City of Beaumont

PROJECT: BRIDGE and STREET IMPROVEMENT along BROOKSIDE AVENUE

SUBJECT: ADDENDUM NO. 3

SEE FILE 1902 FOR CULVERT & RETAINING WALL FOR STRUCTURAL DETAIL

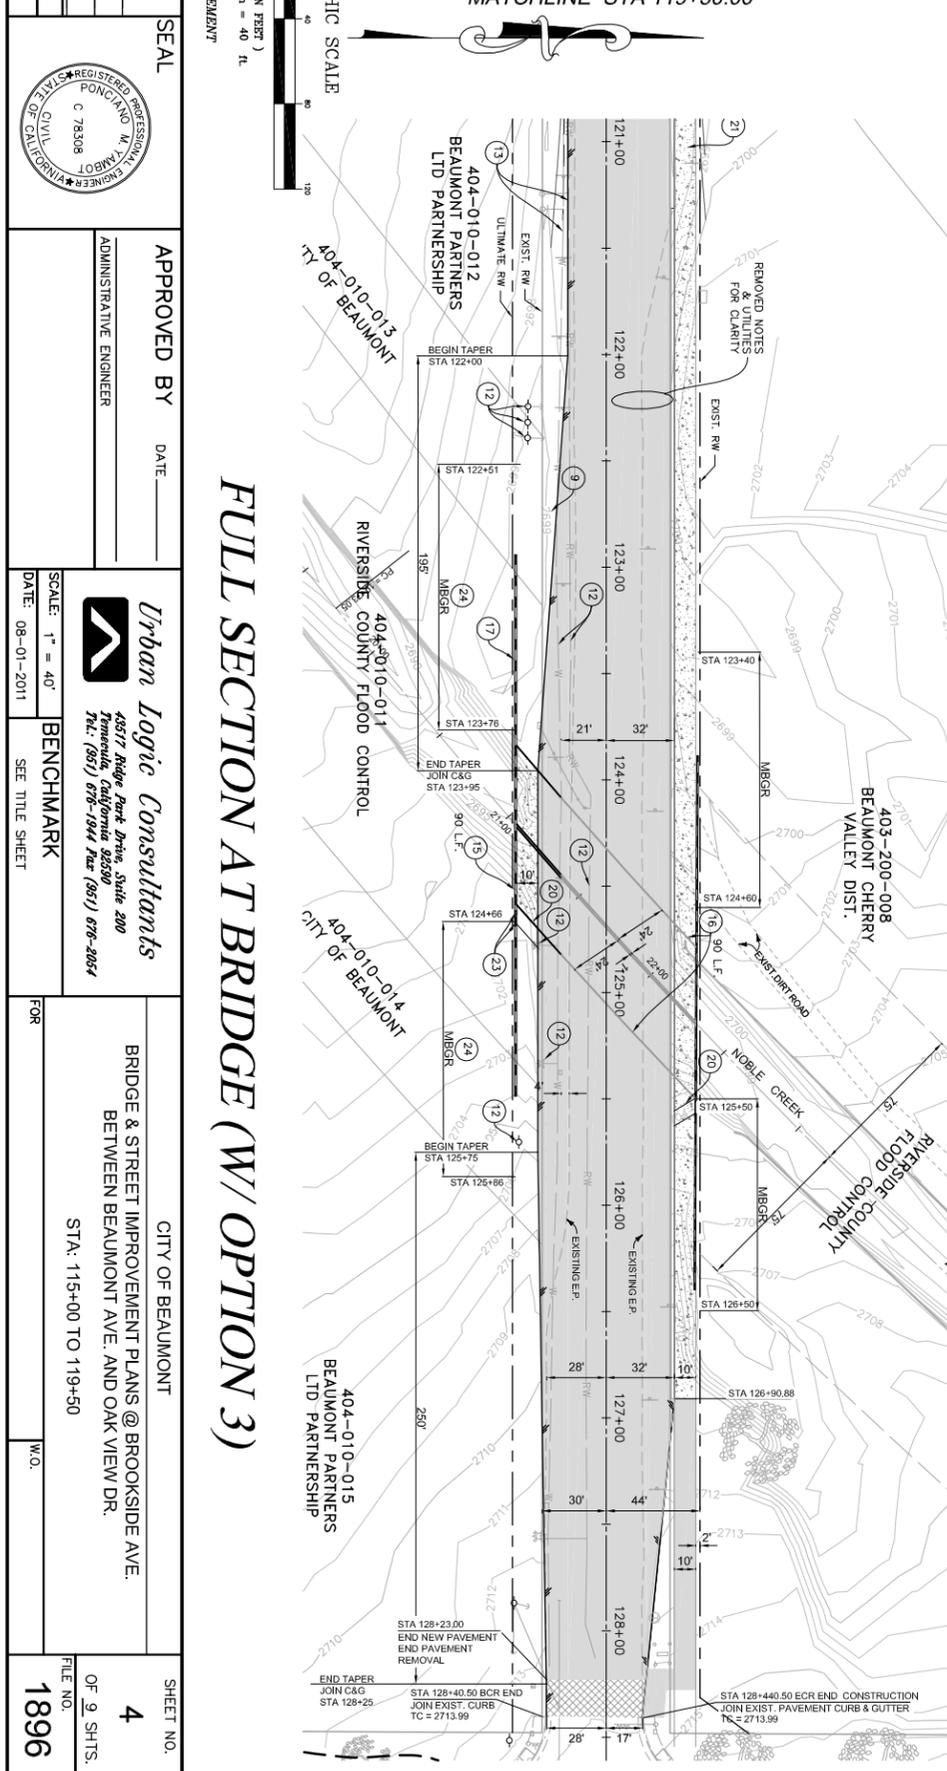
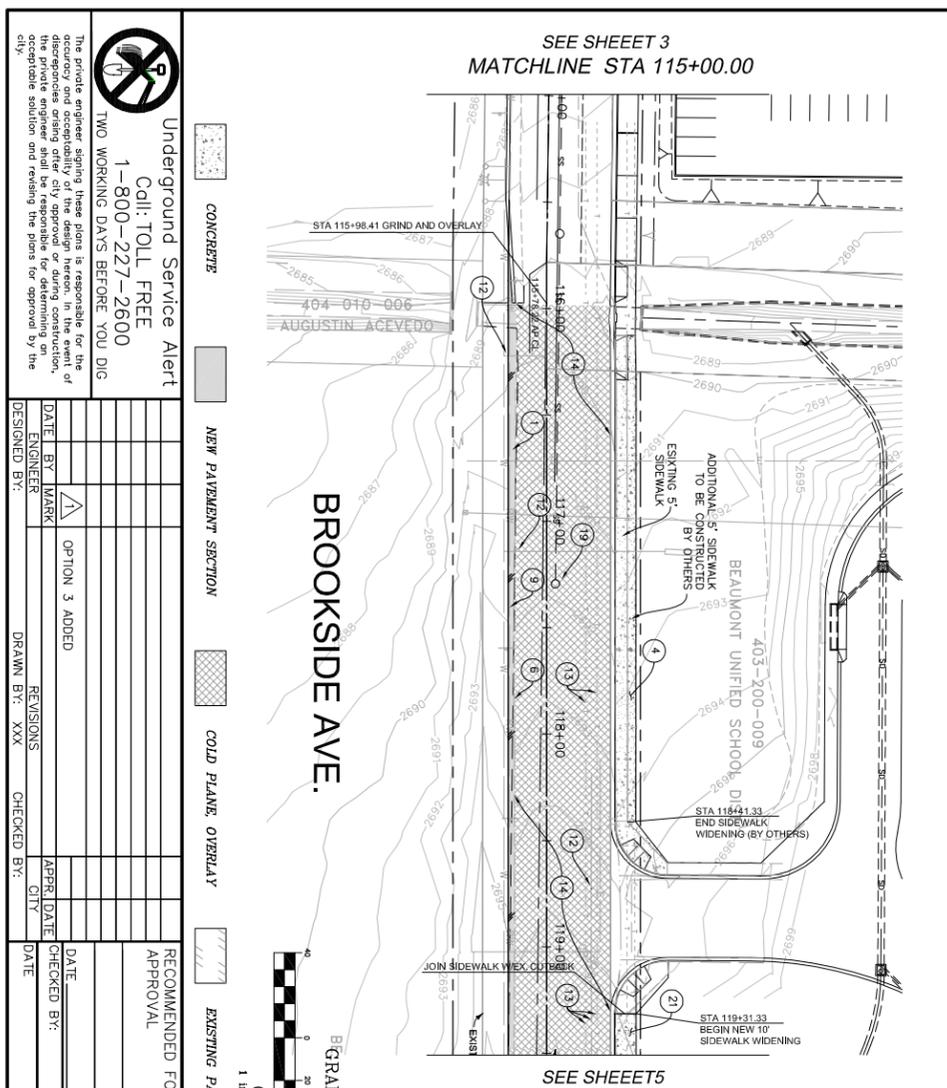
Q9: Where is the detail drawing of the retaining walls of the culvert? On sheet 9, the retaining wall looks like cmu walls.

A9: Sheet 9 of 9 is revised and now show reinforced concrete retaining walls. See Plan File No. 1902 for specifications and details.
